DEVIATION REQUEST  
AND DECISION FORM

Project Name :	Skyline at Lorson Ranch
Schedule No.(s) :	5500000440, 5500000274, 5500000275, 5513300005, 5513310105
Legal Description :	See Attached

SKYLINE AT LORSON RANCH

DEVIATION 2  
 EXHIBIT  
 12/20/2021

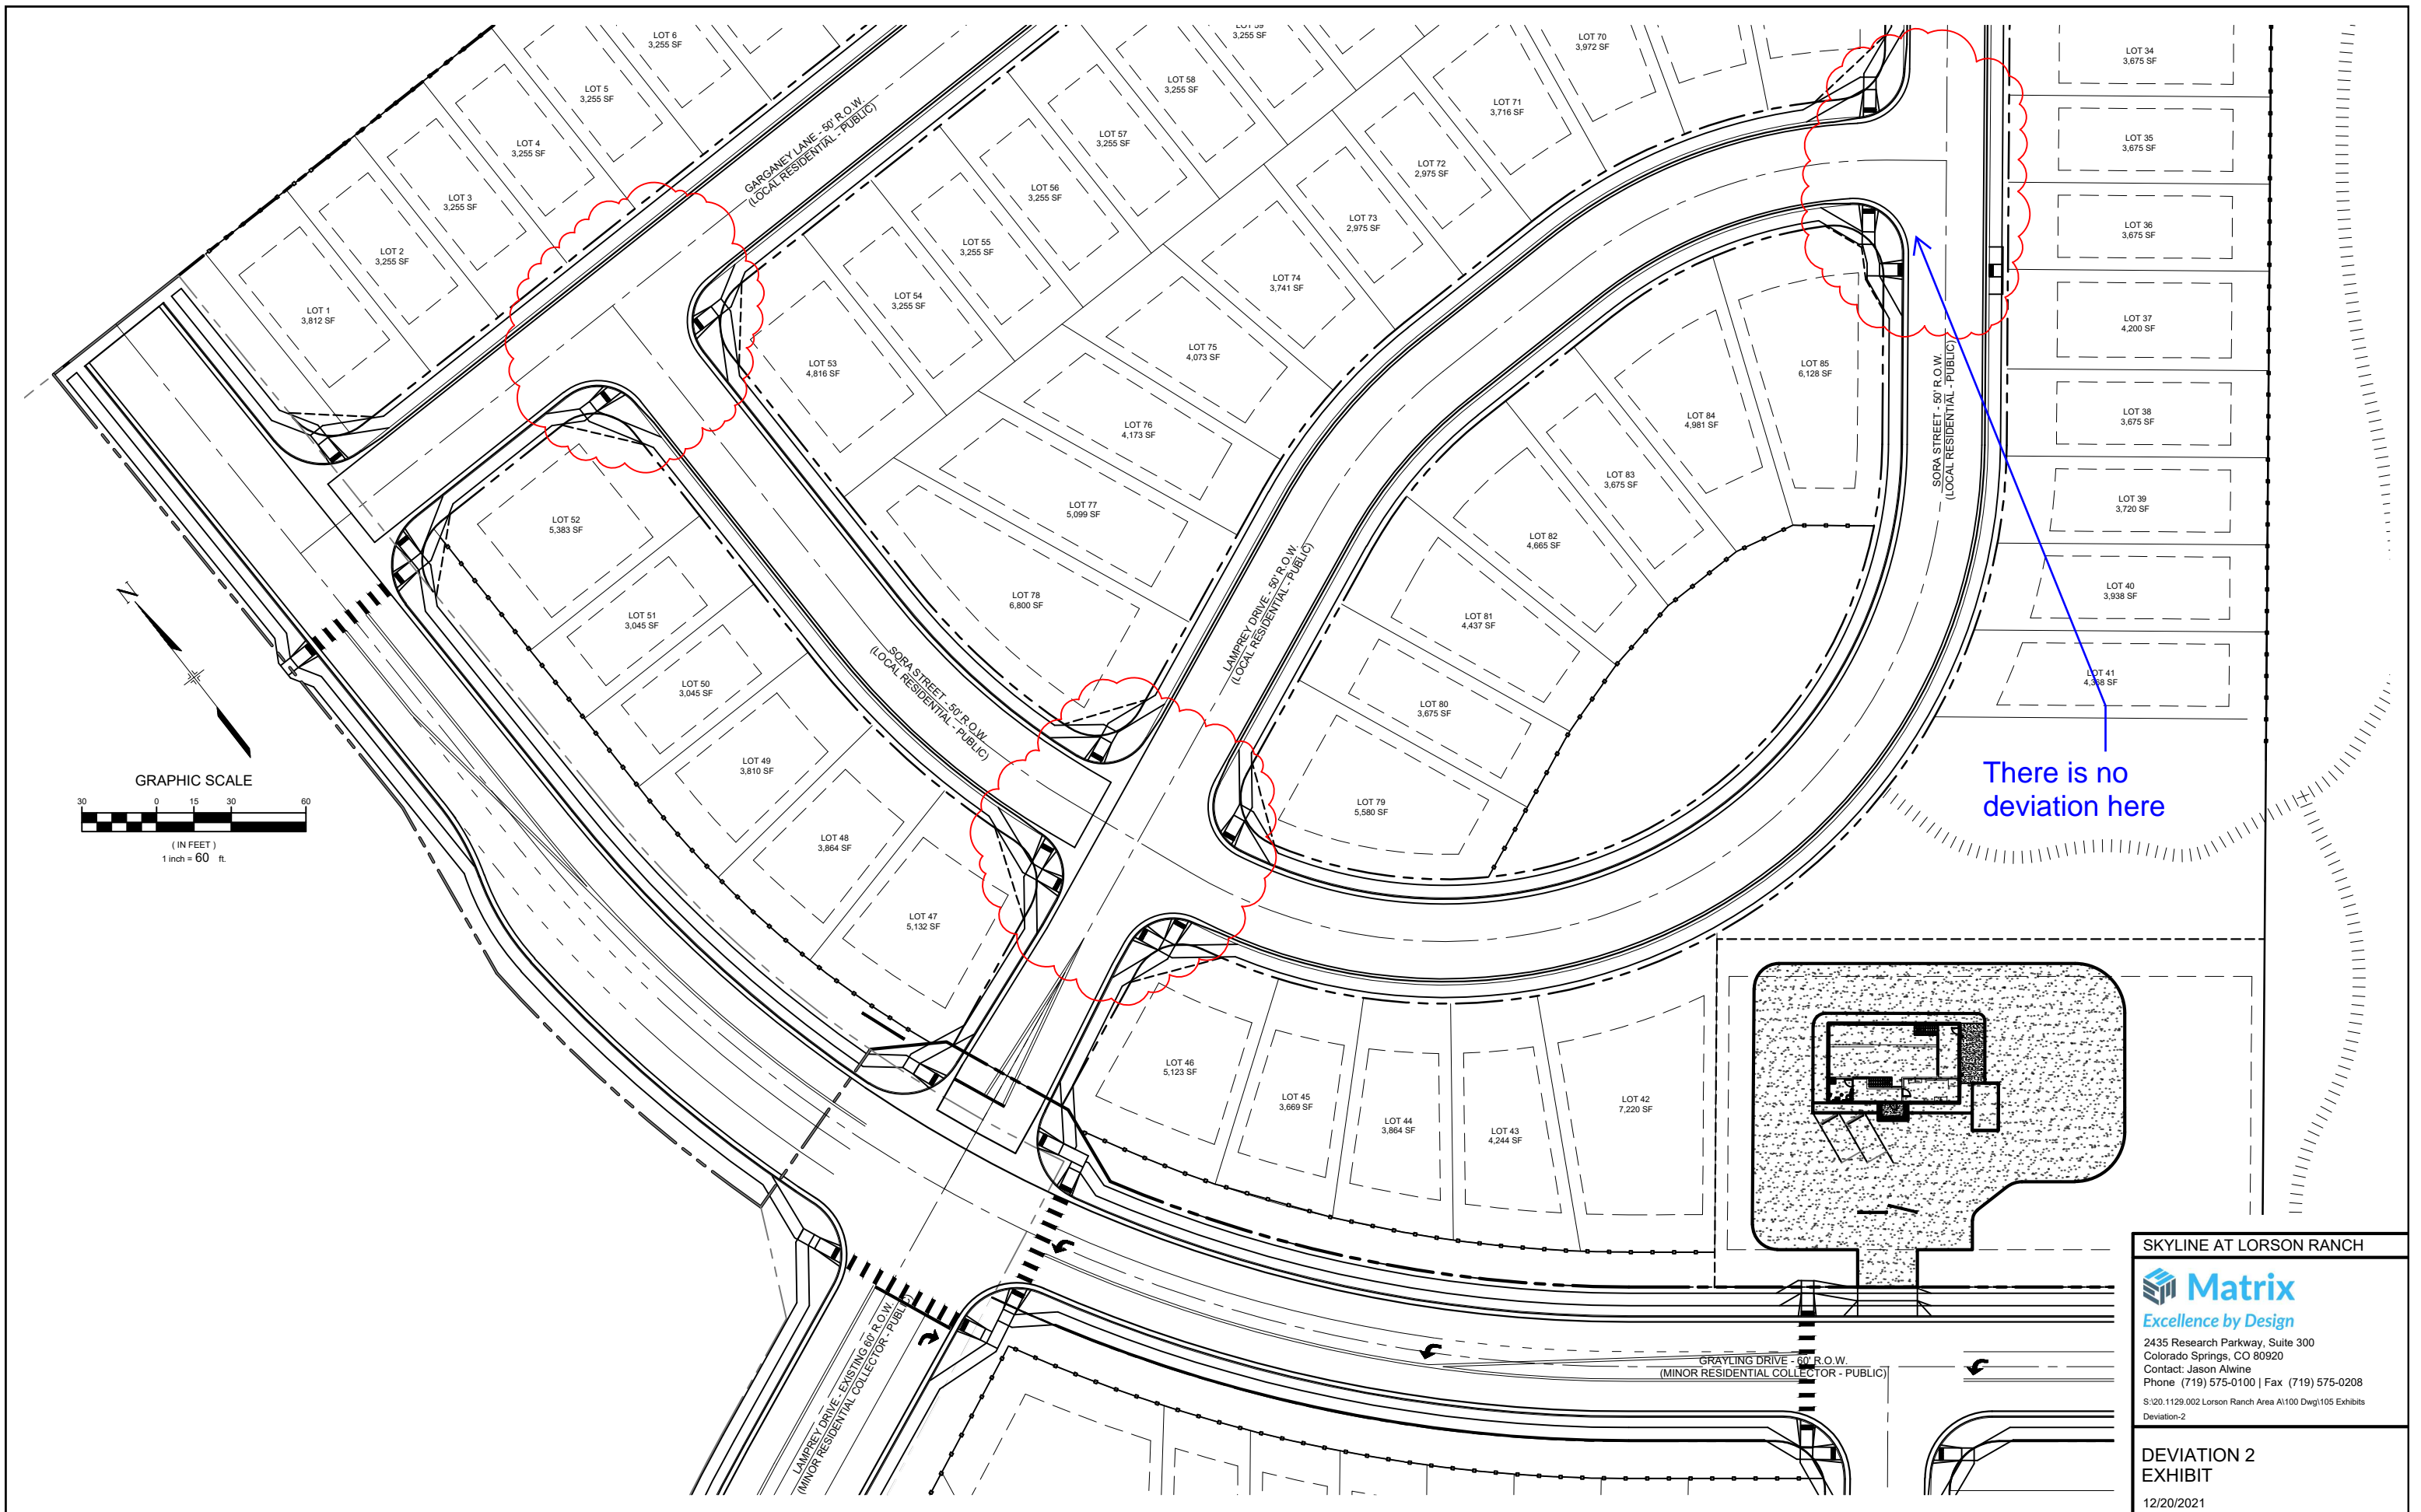
There is no deviation here
